LiDAR Quality Assessment Report

OK_GrandLake_Lidar_Products_2_2011

Grand Lake, OK Lidar Products

pit_1: 36° 29' 50.9" N, 95° 00' 06" W; ~ 53 ft deep.

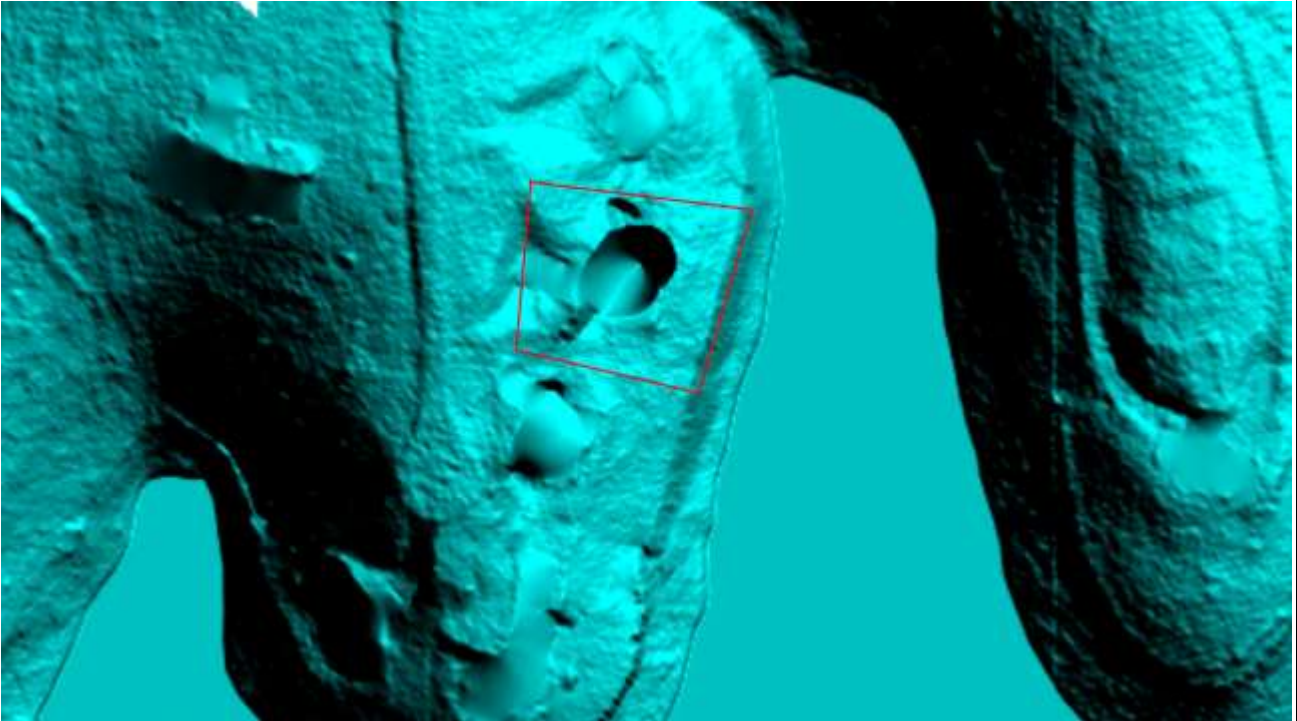
This error will "fixed" by NGTOC personnel so as to be acceptable for the NED.

This error fixed (12/1/2011).

pit_2: 30° 34' 17.8" N, 94° 54' 45.6" W; ~ 26 ft deep.

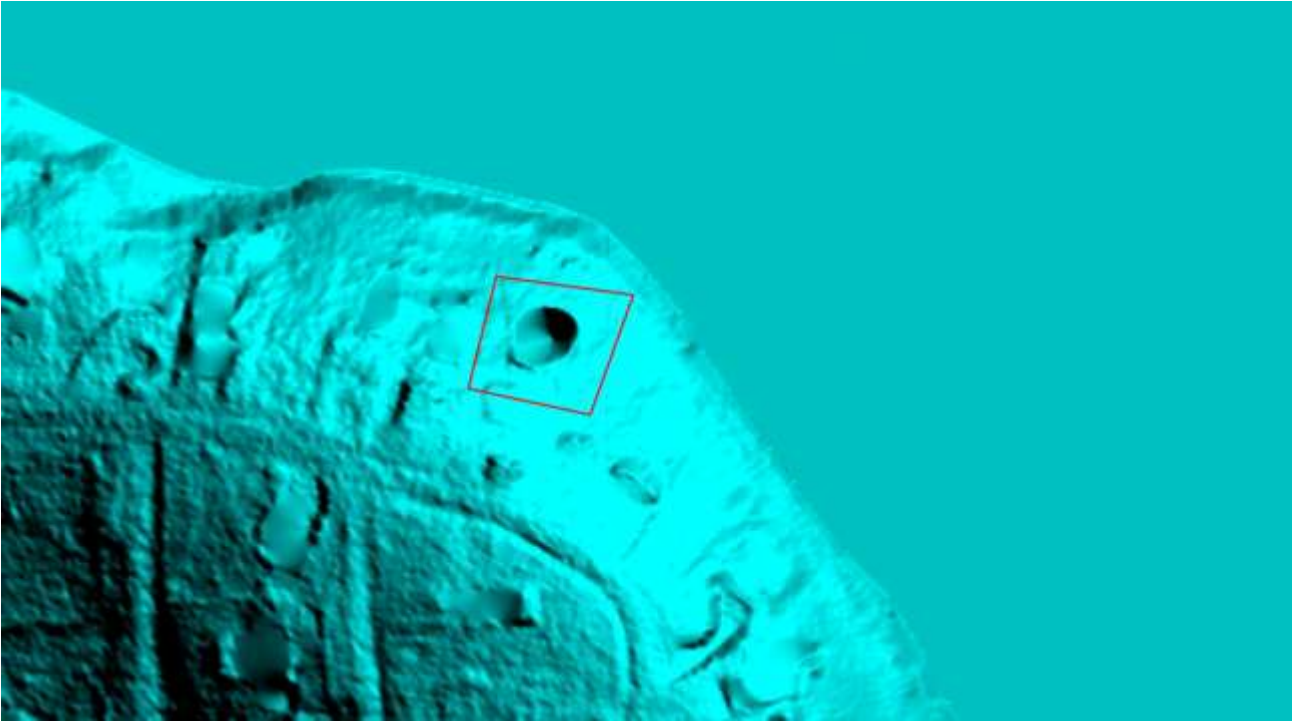
This error will "fixed" by NGTOC personnel so as to be acceptable for the NED.

This error fixed (12/1/2011).
